Sent: 31/08/2020 4:27:37 PM
Subject: DA 2020/0816 33 Bassett St Mona Vale
Attachments: bur.bas37m4_submission_TGNNPLB_310820 (8).pdf;

**DEVELOPMENT APPLICATION DA 2020/0816
23-33 BASSETT STREET MONA VALE
PROPOSED RESIDENTIAL CARE FACILITY UNDER SEPP HOUSING
FOR SENIORS**

This document is a submission by way of objection to Development Application 2020/0816 (the 'development application') relation to Nos 23 - 33 Basset Street Mona Vale (the 'subject property').

Figure 1- North elevation showing west boundary of site and relationship with adjoining cottage style development

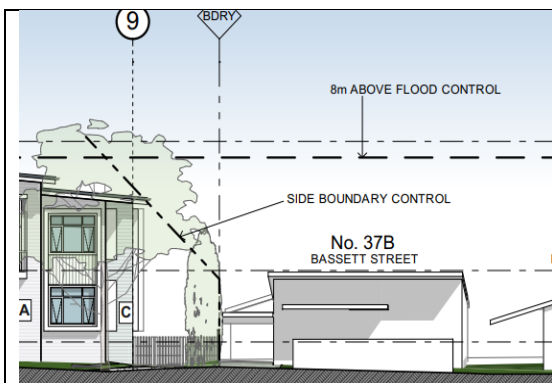
This site is not in a medium density residential zone nor is the property located in a mixed use commercial type environment. The fact that the site is zoned for 'low density residential' purposes should be instructive to the applicant as far as the development proposal is concerned. This is especially the case where low density residential extant development is to be replaced by a high density facility (over the eastern part of the land). We contend that the architect has failed to take into account the reasonable expectations of adjoining land owners and occupiers in this regard. Figures 1 and 2 below show the relationship between the proposal and adjoining development to the east and west (source Gartner Trovato Architects). In our opinion the separation between the built elements in Figure 1 is not acceptable.

Figure 2- North elevation showing east boundary of site and relationship with adjoining cottage style development

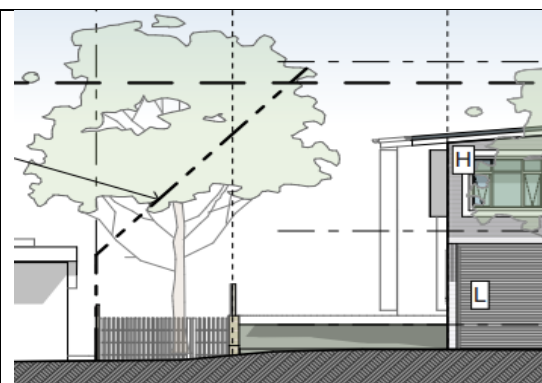
Below is an extract from the drawings by Gartner Trovato Architects, showing the length of proposed building (around 95m total), when viewed from Bassett Street. The long, unarticulated length of this facade, is completely uncharacteristic of adjoining and nearby development. As Council will be aware the existing building is at odds with the nearby building character. When this bulk is extended for a further distance along Bassett Street, a significant change in the dominant character of the southern side of Bassett Street will result. In our minds this is particularly undesirable.
